<b>Subject:</b> <b>CHECK ENGINE LIGHT ON WITH DTC P0452:00 AND/OR P0453:00</b>	<b>Bulletin No:</b> 01-008/14
	<b>Last Issued:</b> 04/01/2014

2013-2015 CX-5 with VINs lower than JM3KE\*\*\*\*\*438362 (produced before Jan. 27, 2014)

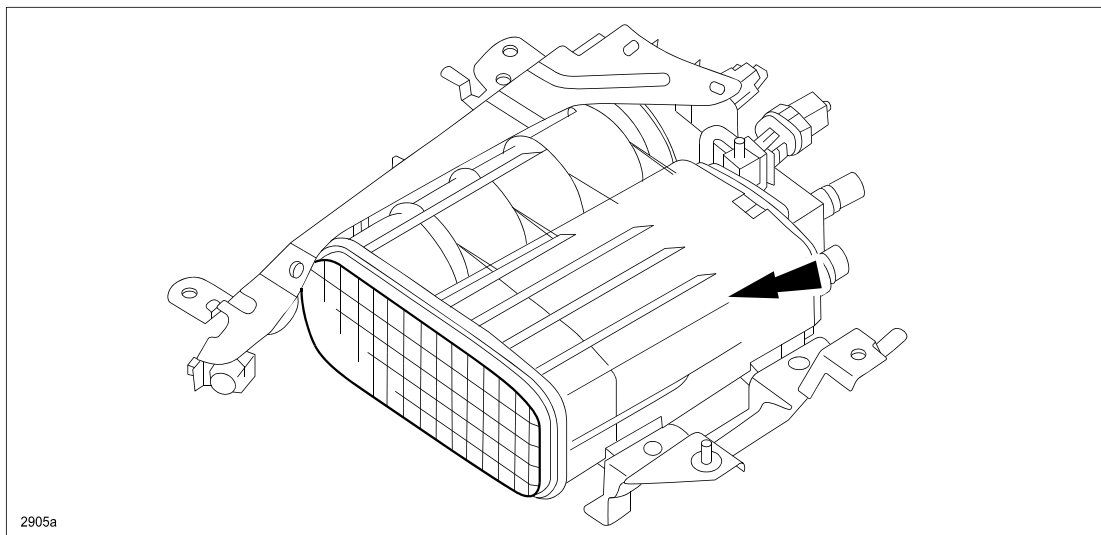
This concern may be caused by ants entering the FTP sensor through an opening (to atmosphere). The ants bite and eventually damage the wiring, which results in an improper FTP sensor output.

To eliminate this concern, the inside of the opening pipe (to atmosphere) has been modified to prevent ants from entering.

1. Verify the customer concern.
2. Replace the charcoal canister assembly (includes FTP sensor) with a modified part according to the instructions on MS3 online or the Workshop Manual (section 01-16 CHARCOAL CANISTER REMOVAL/INSTALLATION [SKYACTIV-G 2.0, SKYACTIV-G 2.5]).
